Vport ad hoc D1.0 Vport related comment resolution

January 2008

Figure 33-9a—PSE PI operating current template

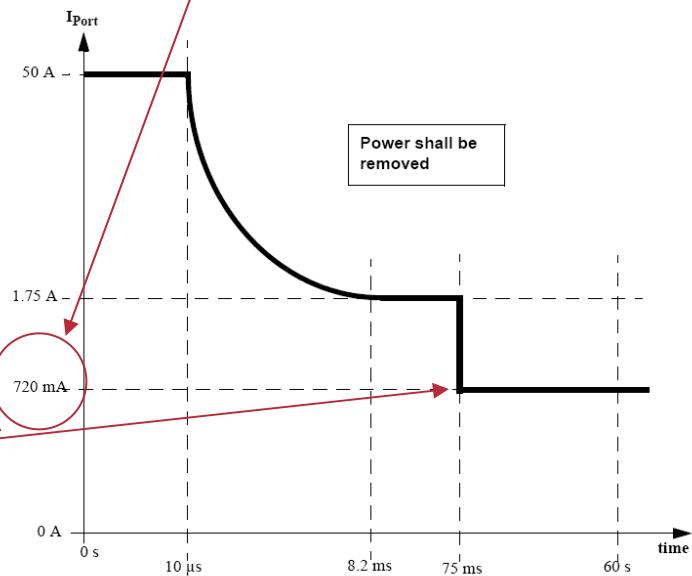
Iport_max is shown with the value I_cable as a MINIMUM required maximum port current. However, I_cable is defined as 720 mA in 33.1.4, and 720 mA is the very top of the allowed current range in Figure 33-9a (formerly SOA curve). So it doesn't seem logical that I_cable can be a MINIMUM value for anything including Iport_max for Type 2 PSE's.

I_cable needs to be clearly defined as EITHER the maximum continuous current (Iport) that can ever exist on a single pair OR if it is to be equated with 803.3af value of Iport_max (MIN) (=350 mA), then it cannot be considered the maximum continuous current allowed on a pair as implied by Figure 33-9a.

This is suppose to be: 400/350Pport/Vport see fig. 33-12b

This says Iport_max > I_cable, I_cable may = 720 mA
This says Iport <= 820 mA, for t > 75 ms

- **Recommend**
Correcting figure 33-9a, and generically using
lcable for type 1 and 2 PSEs in table 33-5.

CI 33 SC figure 33-9a P 44 L 39 # 90

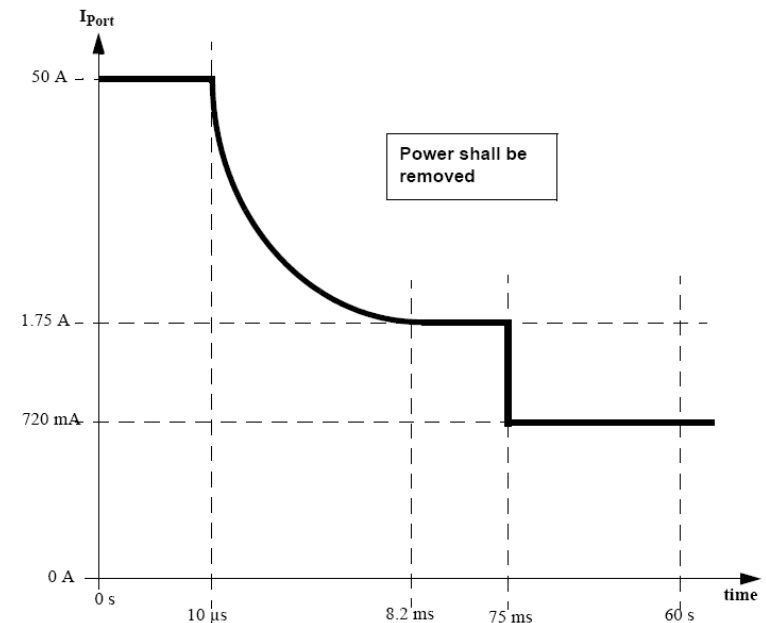
The title of figure 33-9a is "PI operating current template"
It is only defines the maximum current.
In addition it contains error: The current after 75msec is $I_{cable} * 0.4 / 0.35$ and not 720mA.

Delete figure 33-9a and use only figures 33-12b and figures 33-12c due to the fact that they contains PSE and PD data and hence figure 33-9a is redundant.

Fix error in figure 33-9a and change title to read:
"Figure 33-9a - PSE PI maximum operating current vs. Time"

Accept in principle.

OBE by 81 solution.

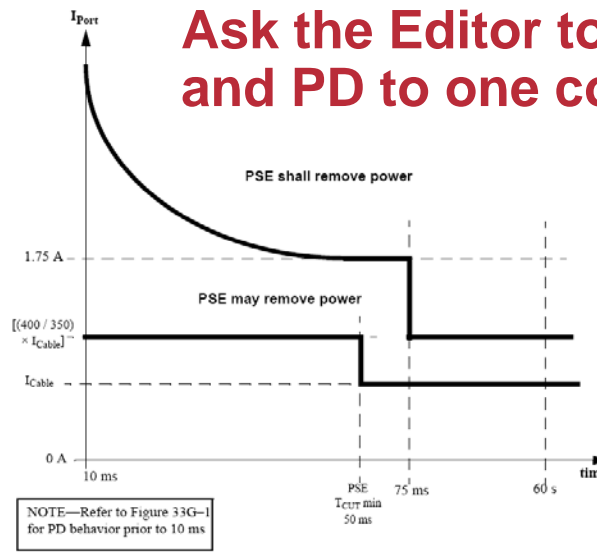
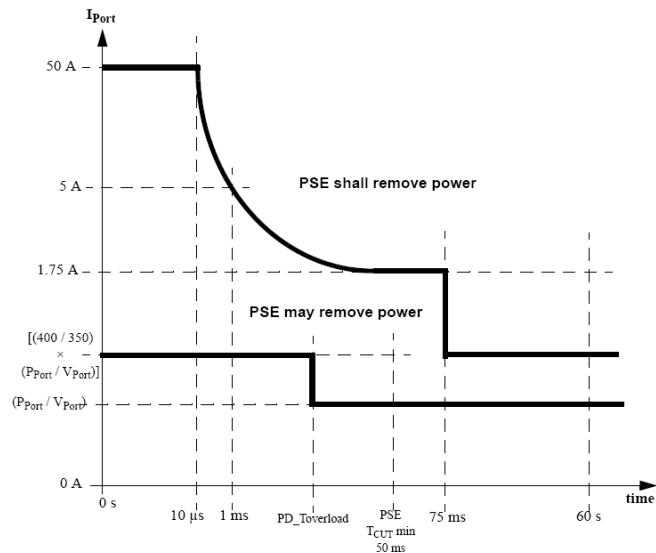
Figure 3-12b and 3-12c
This is PD section and hence the SOA curve for the PSE is irrelevant.

PD_Toverload was defined in the presentation. The maximum value of PD_Toverload is PSE_Tcutmin. Hence PD_Toverload is not relevant anymore.

Remove the SOA curve for the PSE from both the figures.

Remove PD_Toverload and make the overload max duration to PSE_Tcutmin

Explain the mask in text using inequalities.

Accept in principle.

Ask the Editor to point the PSE and PD to one combined curve.

CI 33 SC figure 33-12b P 62 L 31 # 94
Darshan, Yair Microsemi Corporation
Comment Type TR Comment Status D Vport adhoc

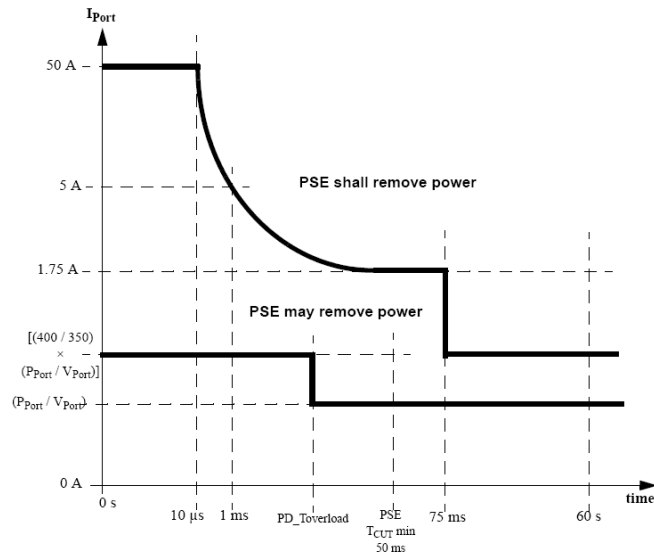
It can be understood from the drawing the PSE may remove power at $I=0.9999999999*(0.4/0.35)*(P_{port}/V_{port})$ and $t=49.99999999msec$ which is incorrect. PSE must not remove power at this region due to the fact that PD allowed to take peak current up to this point. It is ILIM_MIN.

1. Move the solid horizontal line from PD_Tovld to Tcut_min.
 2. Delete PD_Toverload due to the fact that it doesnt add additional information.
 3. Add "PSE shall not remove power" below the PD max. operating current curve.
 4. See figure 33-12c and add the "PSE shall not remove power" below the PD max. operating current curve.
- The rest is OK.

Accept in principle.

OBE by 59 and change Pport to Pport_max, Vport becomes Vport_static.
